Office Action Summary

10/637,973

This is the first office action for application number 10/637,973, Self-Interlocking Hanger System, filed on August 8, 2003.

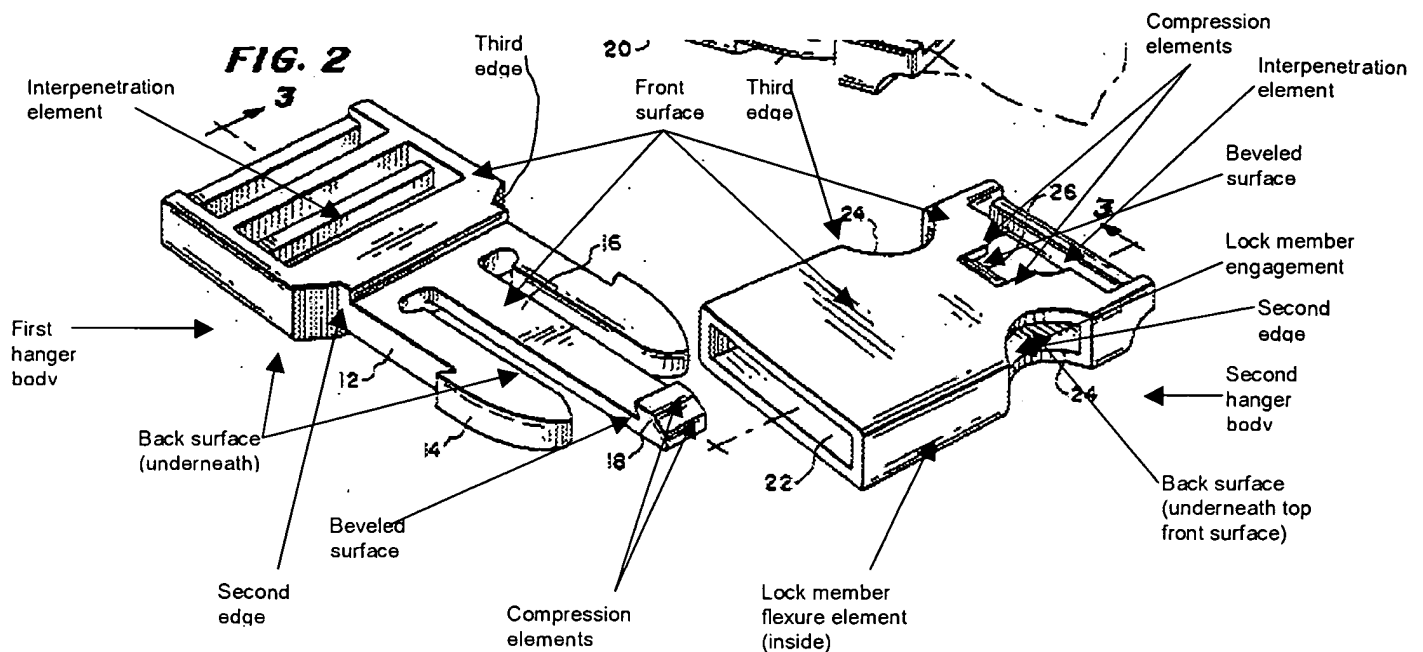
Claims 69-71, 73-81, 82/80, 84 and 85 are rejected under 35 U.S.C. 102(b) as being anticipated by U.S. Patent number 4,825,515 to Wolterstorff, Jr.

Wolterstorff, Jr. '515 discloses a hanger (above) comprising a first hanger body (above) having a front surface and a back surface (above) that terminate in a first edge having a beveled surface (above); at least one lock member (12) which extends from said first hanger body; a second hanger body (above) having a front surface and a back surface which terminate in an edge having a beveled surface (above), wherein said beveled surface of said first hanger body and said beveled surface of said second hanger body are configured to engage in opposed mated relation; wherein the at least one lock member engagement (above) has a surface configured to engage the at least one lock member to establish locked securement of the first hanger body to the second hanger body in opposed mated relation; wherein the lock member comprises a resiliently flexible projection which terminates in a catch element (14); wherein the lock member engagement comprises a lock member flexure element (above) which slidingly engages the catch element to generate flexure of said resiliently flexible projection

sufficient to allow the catch element to engage the catch element engagement surface; wherein the front surface and the back surface of said first hanger body terminate in a second edge (above) and a third edge (above) and wherein the at least one lock member comprises two lock members (12, both sides) one each extending from the second edge and the third edge; wherein the front surface and the back surface of the second hanger body further terminates in a second edge (above) and a third edge and wherein the at least one lock member engagement comprises each of the second edge and the third edge configured to provide one each lock member engagement; wherein the hanger further comprises a compression element (above, inherently, this element could be involved in the compression of some item/object) which projects from the beveled surface of the first hanger body, and a compression element (above, inherently, this element could be involved in the compression of some item/object) which projects from the beveled surface of the second hanger body; wherein the compression element which projects from the beveled surface of the first hanger body and the compression element which projects from the beveled surface of said second hanger body each comprise a single continuous compression element which projects from each beveled surface; wherein the compression element which projects from the beveled surface of the first hanger body and the compression element which projects from the beveled surface of the second hanger body each comprise a pair of compression elements (above) which project from each beveled surface, wherein each of the continuous compression elements further comprise an inclined surface (inherently, it is inclined relative to some reference point) which intersects each beveled surface, wherein an

interpenetration element (above, inherently, each could be interpenetrated by some object/item) is between the front surface and back surface of each of the first and second hanger bodies.
